Salinas Valley Water Coalition

22 October 2025

Re: Comments on April 2025 Salinas Valley Historical Benefits Analysis Update and May 29, 2025, Draft Interlake Tunnel and San Antonio Spillway Modification Assessment Engineers Report

Subject: Technical Review Comments on the MCWRA Historical Benefits Analysis and Draft

Figure 1-6 (HBA, 1998) of average increase in water levels elevations resulting from reservoir options from the 1998 HBA modeling.

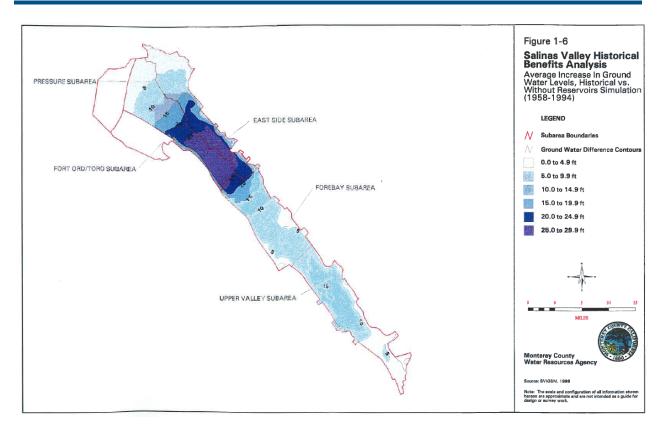
The unacceptable use of the drains in the SVIHM model version used for the HBA Update analysis is also a likely explanatory reason for the noticeably different model outcomes for predicted water level elevation changes with and without the reservoirs in the 1998 versus 2025 HBA modeling. Predicted groundwater elevation changes as a result of historical reservoir operations were notable in the southern Pressure Subbasin and north Forebay Subbasin in the 1998 SVIGSM modeling, with average water level elevation increases of 10-25 ft (see Figure 1-6 from the 1998 HBA report, included below). Over most of the Salinas Valley, the 1998 modeling indicated a 5-10 ft average water level increase. By comparison, the 2025 HBA Update modeling predicts essentially no average annual water level increase as a result of the reservoirs, with only modest increase directly along the river, and more substantial water level increases in the northern Pressure subbasin as a direct result of CSIP/SRDF. In review of available historical water level elevation data, it appears that a historical rise in water level elevations post-reservoirs (1958 for Nacimiento) as represented in the 1998 modeling is supported by the data, but perhaps of a more modest magnitude of approximately 5-15 ft (reference is made to hydrographs of water level elevations for 1948-1994 in the Appendix A to the HBA, Montgomery Watson, 1998).

The lack of predicted water level elevation responses from the reservoir operations and inconsistency with the prior body of work from the 1998 HBA modeling, which was a significantly peer reviewed effort, should have led to questioning of the validity of the results being observed in the HBA Updated modeling.
